Access Compliance Report

Public Rights-of-Way

(Curb Ramps)

Intersection ID: 24562	Main Street: CAVAN_CT	Cross Street: SWINFORD_PL	Location: NW
ADA ID: 2B2E150AF9D4	Ramp Type: Perp	Initial Pass/Fail: Fail	Overall Compliance: No
		Severity Score: 12.5

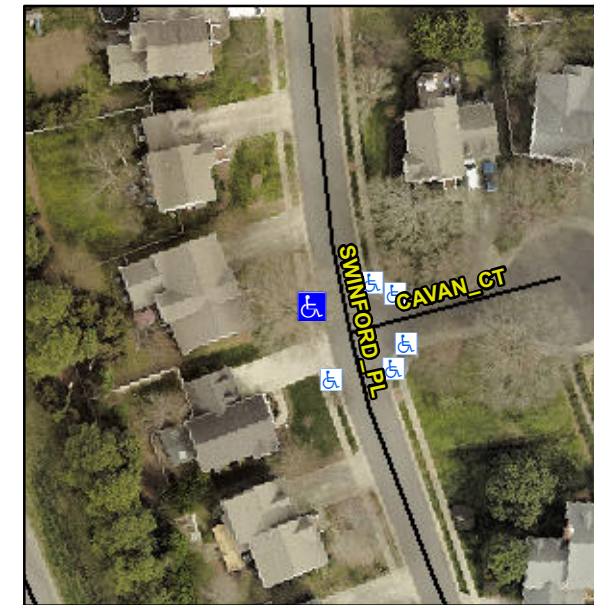
R304.2.2

Compliance	Description	Data	Compliance	Description	Data
N/A	Ramp Length (in)	48.0	No	Ramp Slope (%)	8.8
Yes	Ramp Width (in)	48.0	Yes	Ramp XSlope (%)	1.7
N/A	Flare Type LT	N/A	N/A	Flare Type RT	N/A
N/A	Flare Slope LT (%)	N/A	N/A	Flare Slope RT (%)	N/A
N/A	Flare Traversable LT?	N/A	N/A	Flare Traversable RT?	N/A
N/A	Landing Length (in)	N/A	N/A	DWS Provided?	N/A
N/A	Landing Width (in)	N/A	N/A	DWS Contrast?	N/A
N/A	Landing Slope (%)	N/A	N/A	DWS Length (in)	N/A
N/A	Landing X Slope (%)	N/A	N/A	DWS Full Width?	N/A
N/A	Landing Curb? (Y/N)	N/A	N/A	DWS Offset (in)	N/A
N/A	Shared Landing?	N/A			
N/A	Gutter Ponding?	N/A	N/A	Gutter Slope (%)	N/A
N/A	Gutter Lip Ht (in)	N/A	N/A	Gutter X Slope (%)	N/A
N/A	Painted X Walk1?	No	N/A	Painted X Walk2?	N/A
	X Walk 1 Direction	To E		X Walk 2 Direction	N/A
N/A	X Walk 1 Width (in)	N/A	N/A	X Walk 2 Width (in)	N/A
	X Walk 1 Slope (%)	2.8		X Walk 2 Slope (%)	N/A
	X Walk 1 X Slope (%)	0.0		X Walk 2 X Slope (%)	N/A

Remove & Replace Entire Ramp.
